And A requested change to the Mount Cardrona Station Special
Zone of the Queenstown Lakes District Council's Operative
District Plan – **Plan Change 52**

Requestor right of reply

Mt Cardrona Station Limited

Dated 13 October 2017

STRUCTURE PLAN D - MITIGATION, EARTHWORKS AND PLANTING PLAN

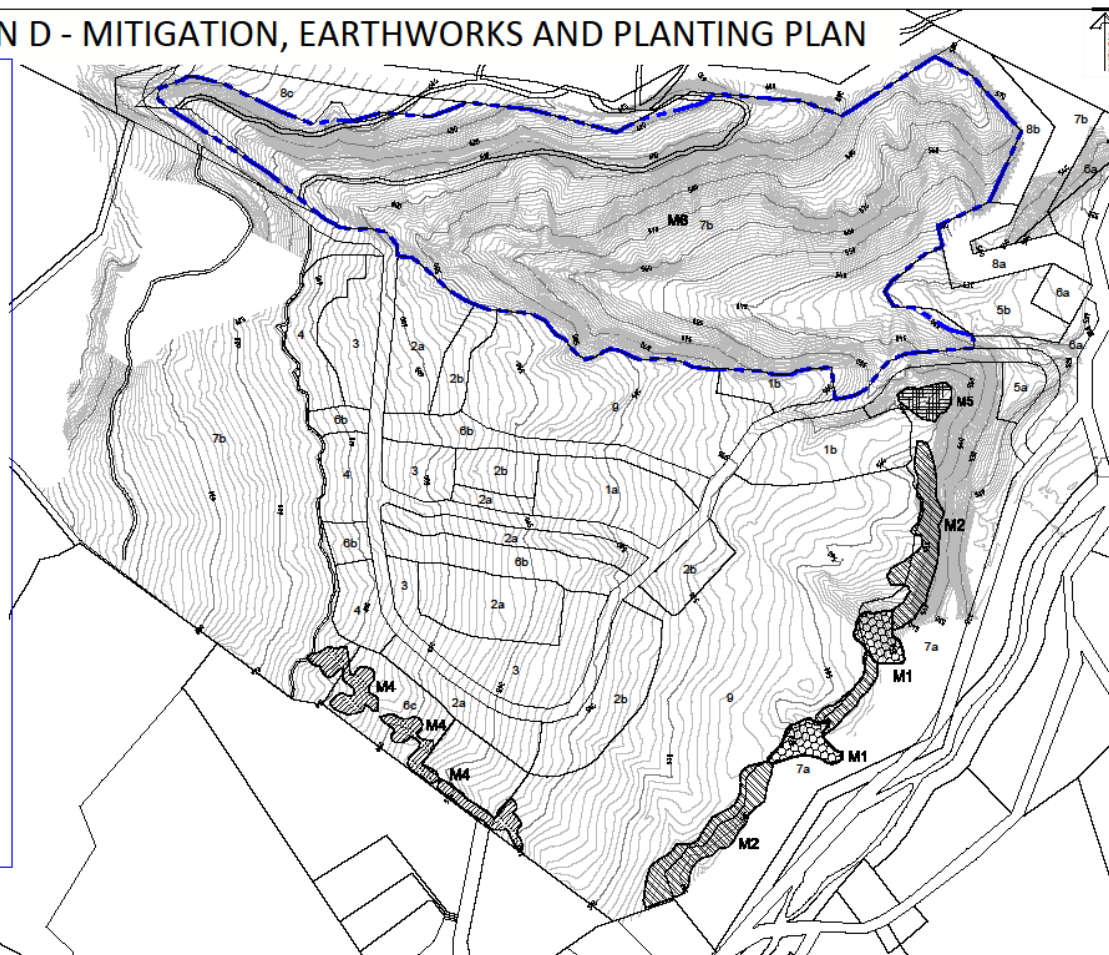
No building shall be erected within Activity Areas 1b, ~~3a and 3b~~ or in the Southern Neighbourhood (as shown on Structure Plan A) prior to the Mitigation Earthworks and Planting Plan (MEPP) (Structure Plan D) being approved ~~and implemented~~ pursuant to ~~Controlled Activity Rule 12.22.32.2(v) and implemented~~. Mitigation planting area M4 (as shown on Structure Plan D) shall be planted at commencement of development occurring on-site. For the areas of M4 at higher elevations (adjacent to Activity Area 4) the mitigation shall comprise earth mounding with native grasses, low tussocks and shrub species.

Prior to the commencement of development occurring on-site, the pines species in mitigation planting area M5 (as shown on Structure Plan D) shall be removed and the area replanted in accordance with the Mount Cardrona Station Design Guidelines 2017.
